Sydney Metro Design
Review Panel
Letter of Design Excellence Pitt
Street South Over Station
Development

Pitt Street North Over Station Development – Design Excellence

Advice and Actions Record – 14-15 September 2020

The Pitt Street ISD project team presented DRP presentation 13 which covered the responses to submissions to OSD North, and the facade depth of OSD South.

Comparison overshadowing to Park Regis Tower

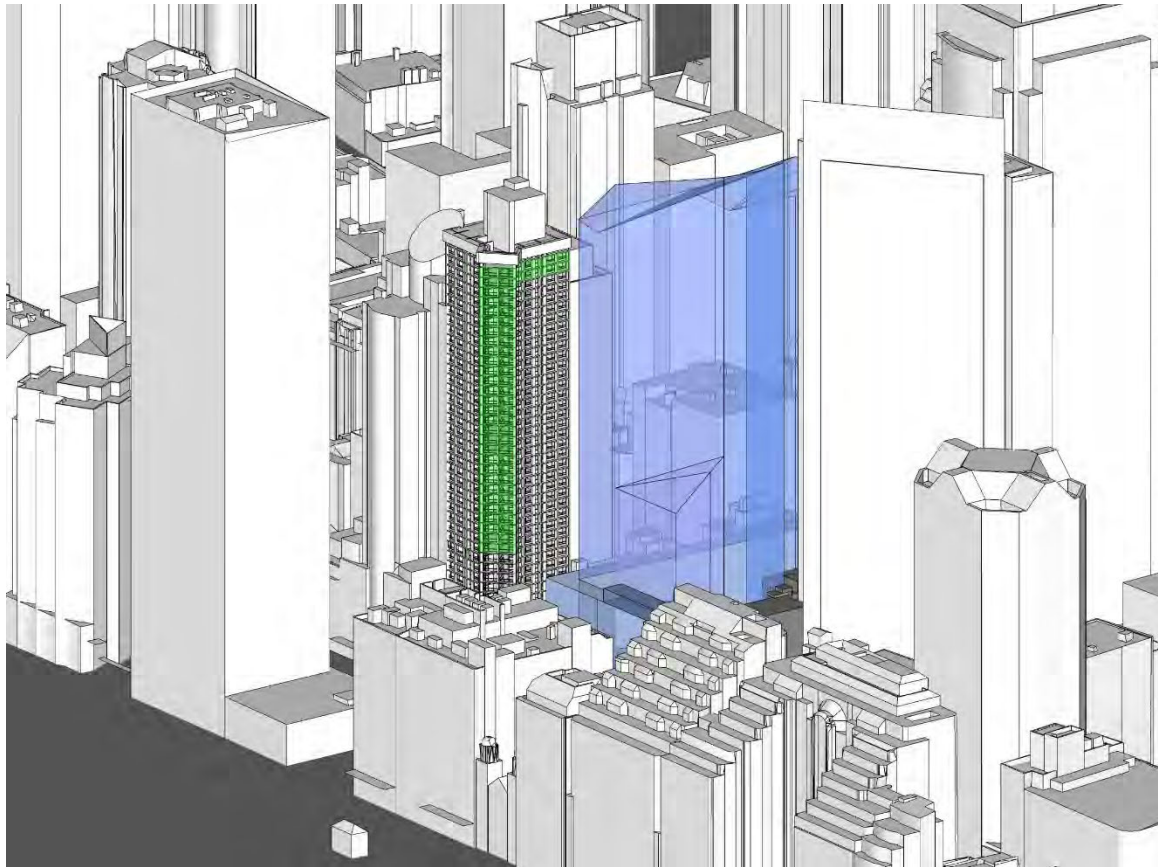
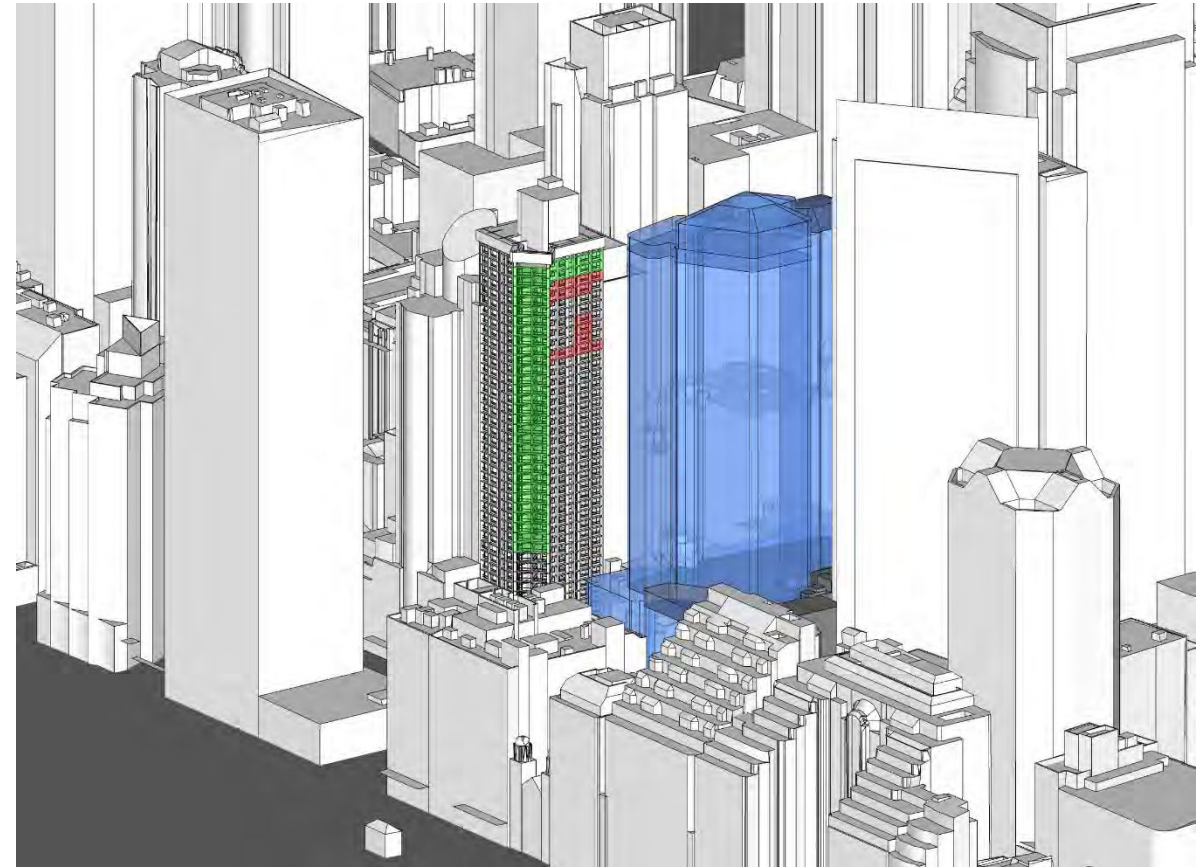
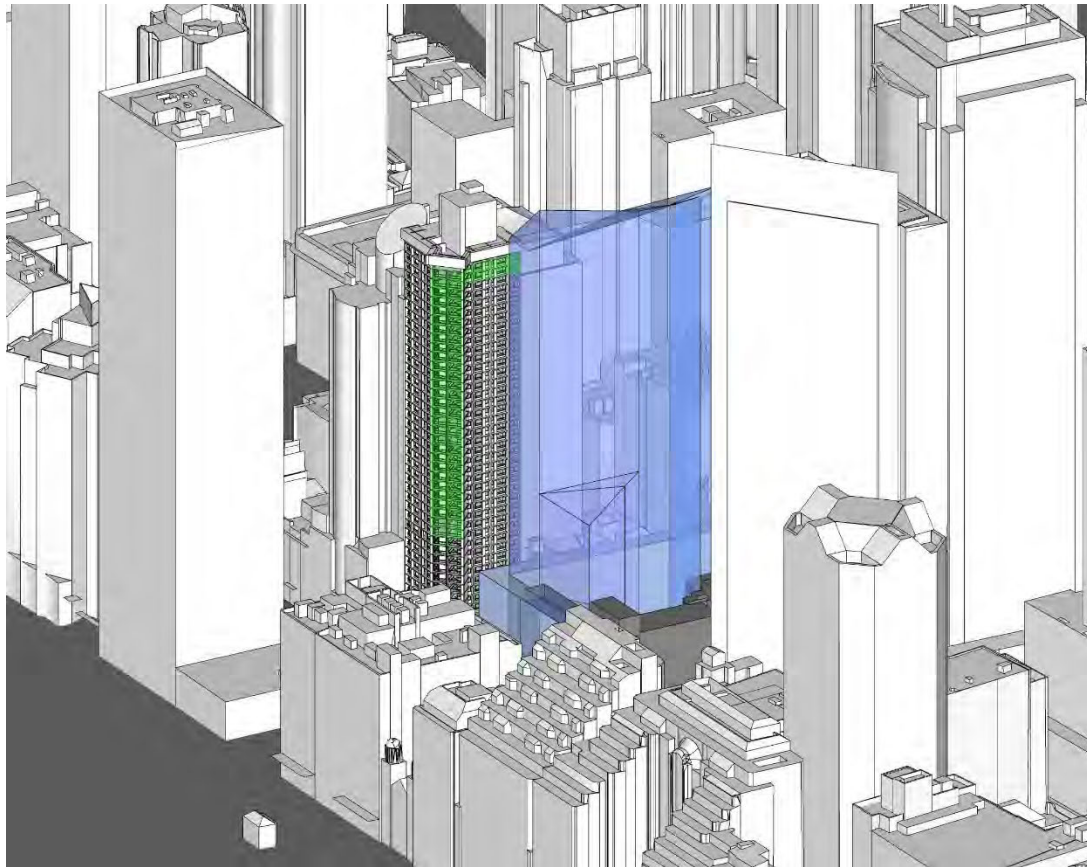
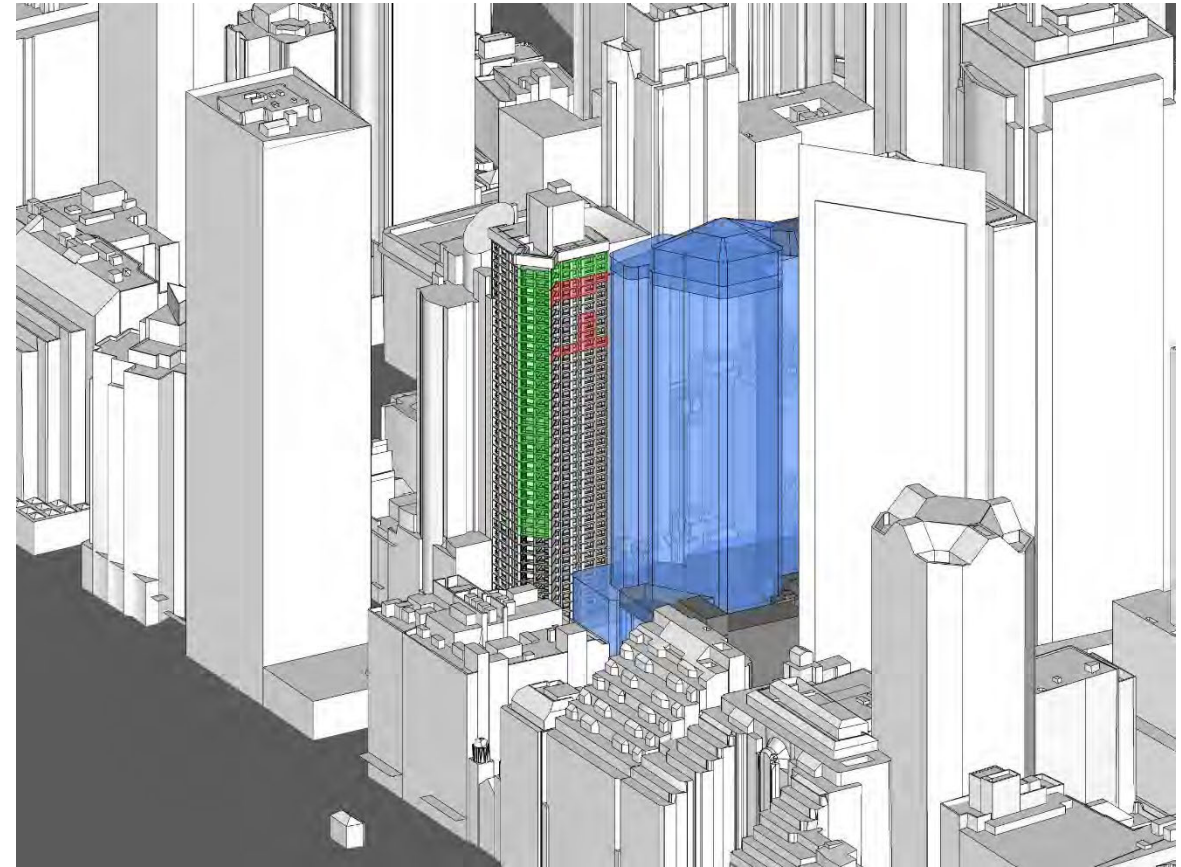
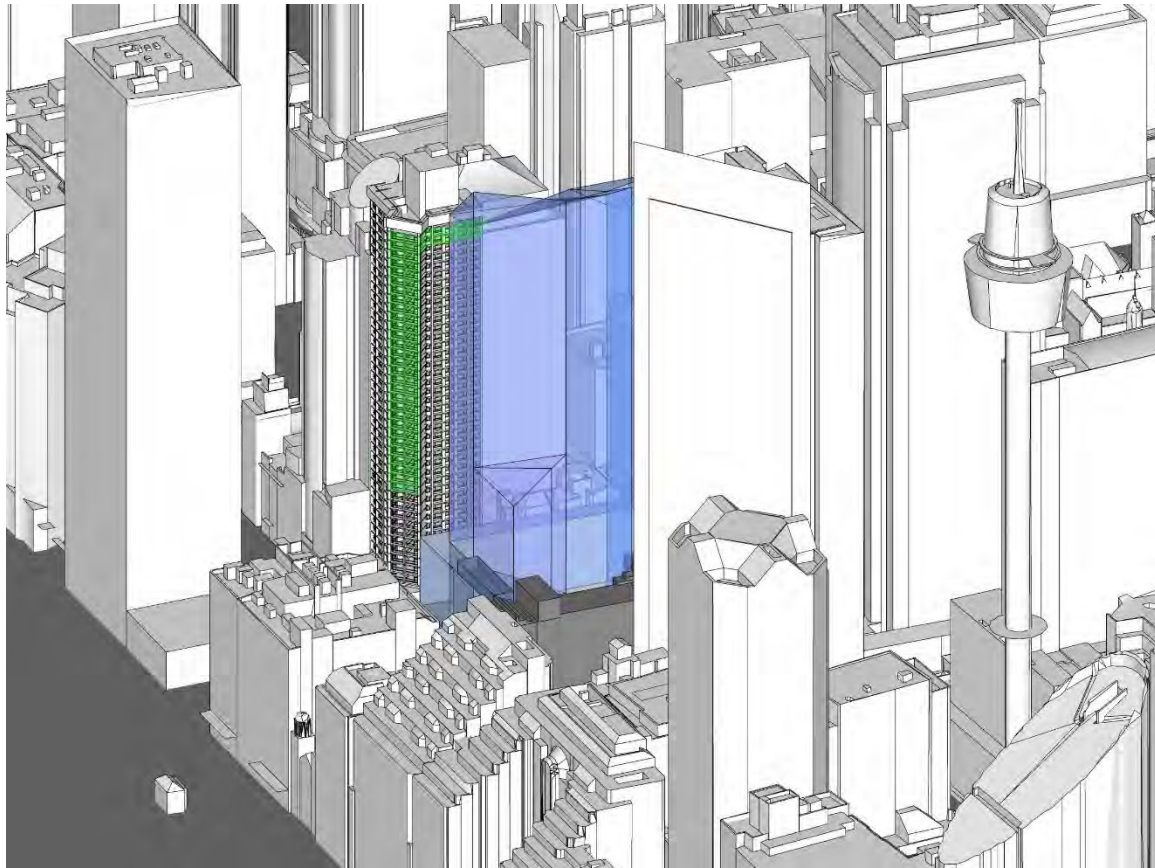
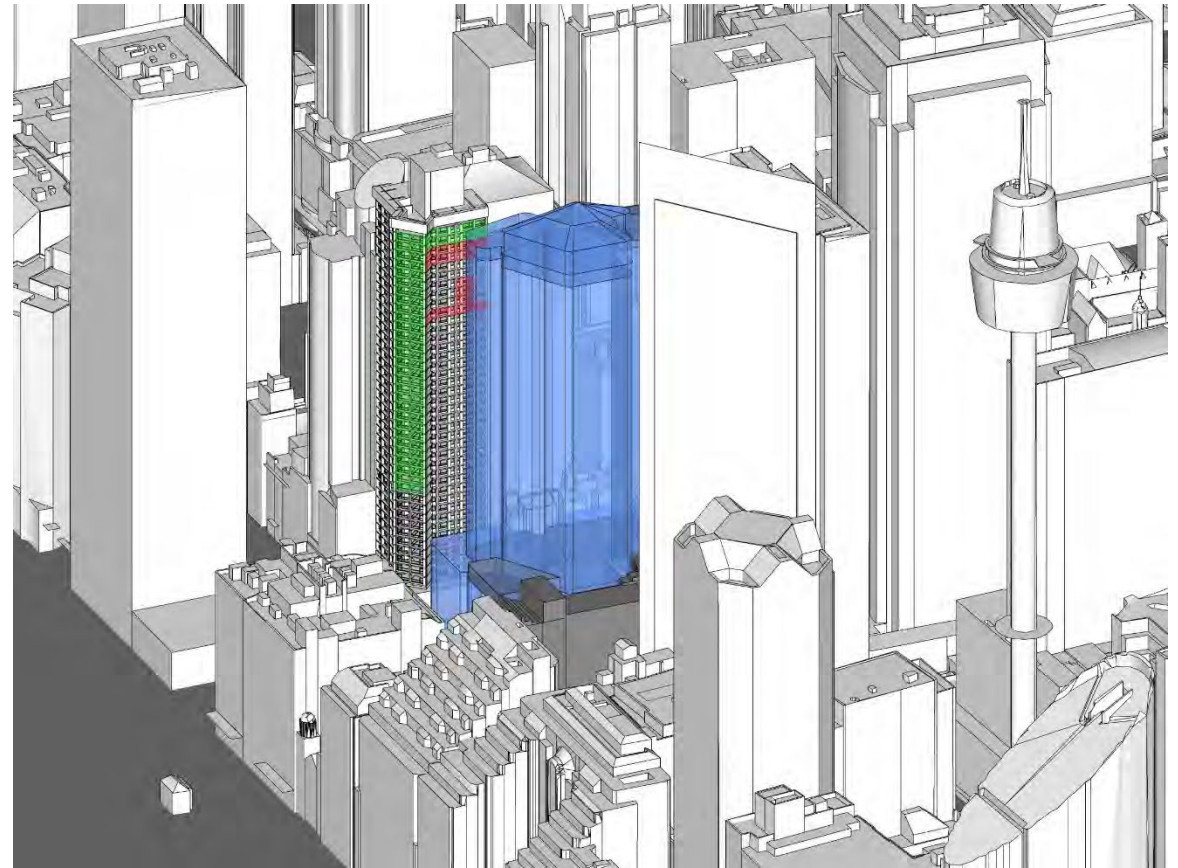
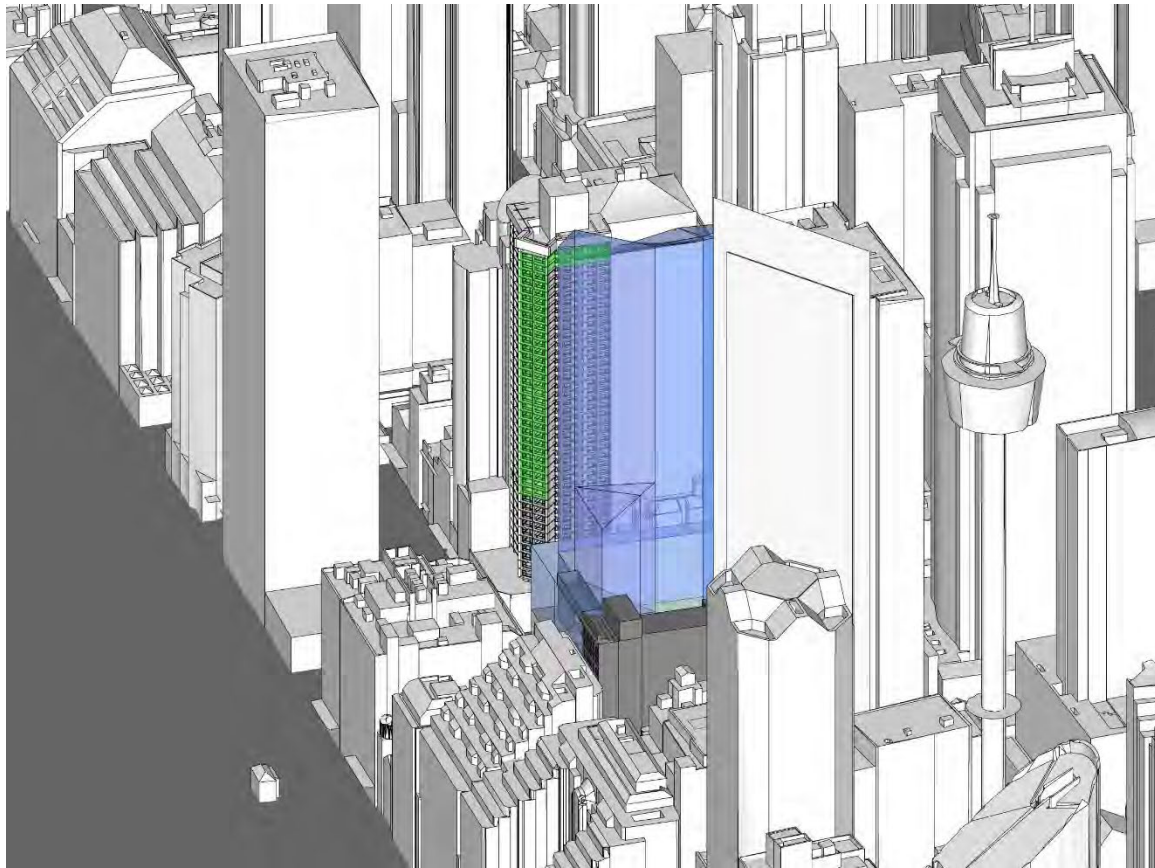
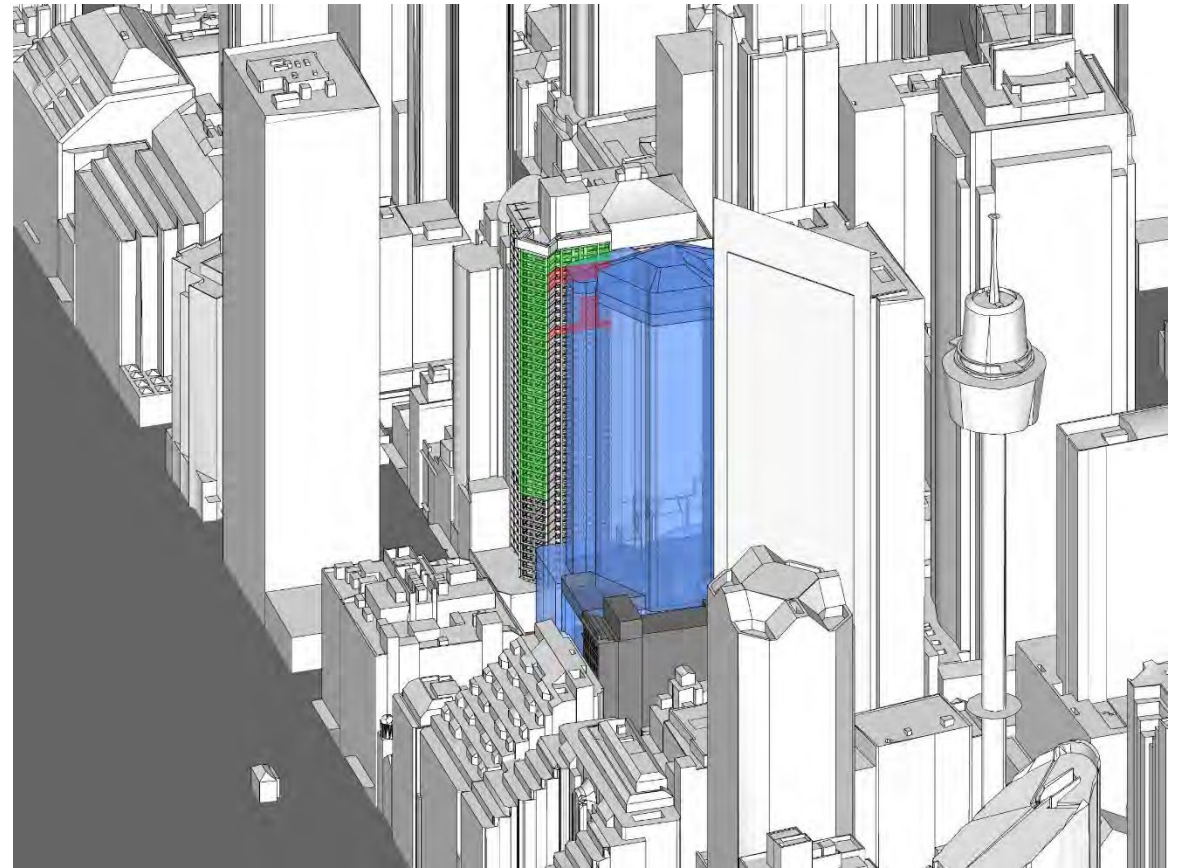
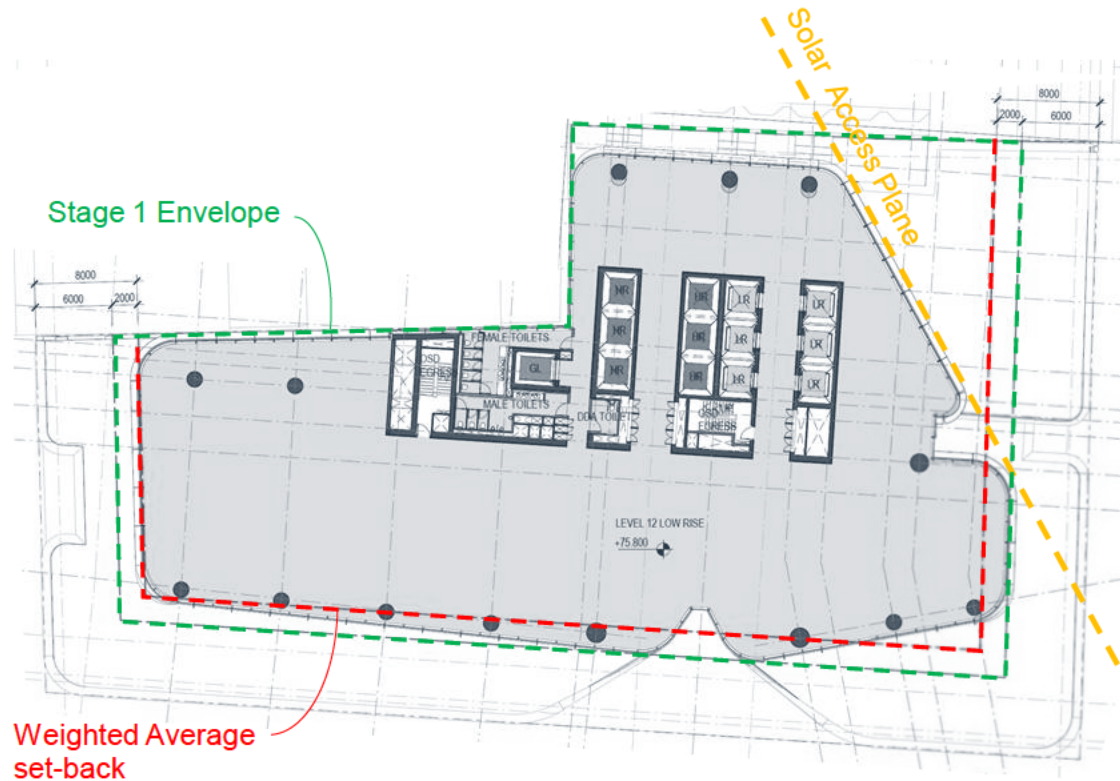
12.02	OSD North	Built Form	15/09/2020	DRP 13 Presenation	Neighbouring apartment solar access The Panel defers to DPIE for compliance decisions relating to overshadowing of surrounding residences.	N/A			Closed

(9.c) Minimise overshadowing impacts to surrounding residences, including private residences at 27 Park Street (Park Regis).

L10/11 Tower Facade impression – SW corner

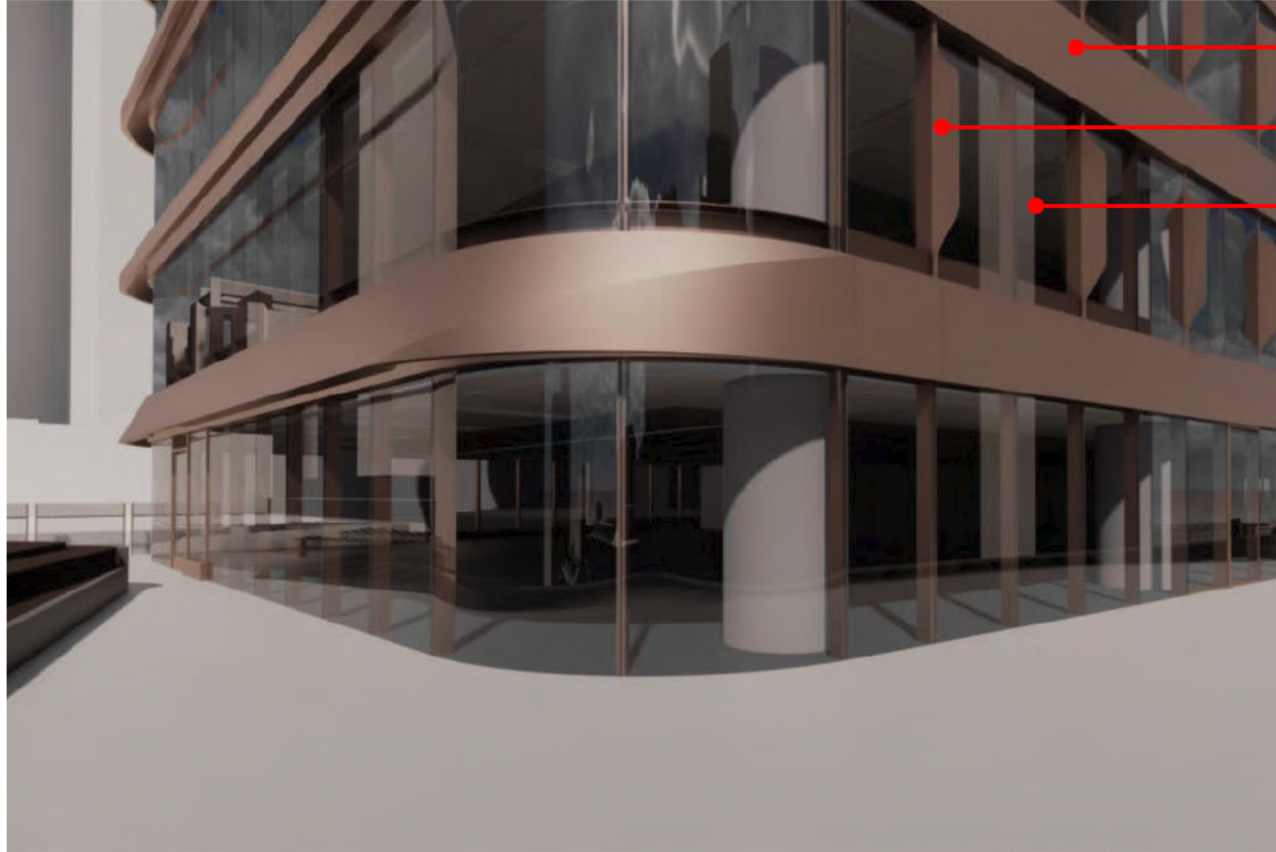
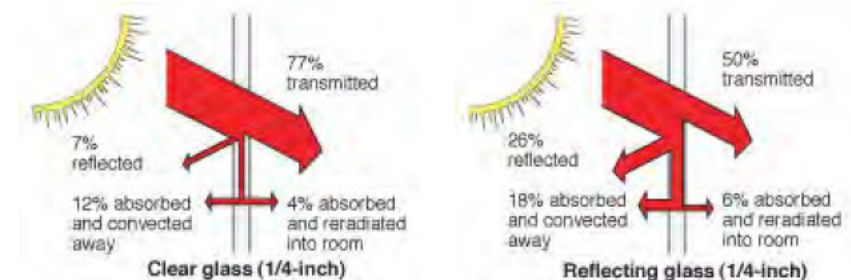
- The Panel supports the measures taken to minimise reflectivity to protect Powerful Owls and other birds from flying into the building facade glazing and balustrades.

12.04	OSD North	Materials and finishes	15/09/2020	DRP 13 Presenation	Bird protection The Panel supports the measures taken to minimise reflectivity to protect Powerful Owls and other birds from flying into the building facade glazing and balustrades.	N/A			Closed

The City requests the applicant provide details of a localised translucent glazing treatment that will ensure the glazed screen is visible to birds, particularly any threatened or vulnerable species and species of local conservation significance (refer to the City's Urban Ecology Strategic Action Plan).

Solid spandrels and expressed sunhoods
(reduction overall glass surface to less than 70%)

Vertical fins on the Southern facade (obstruct reflections)
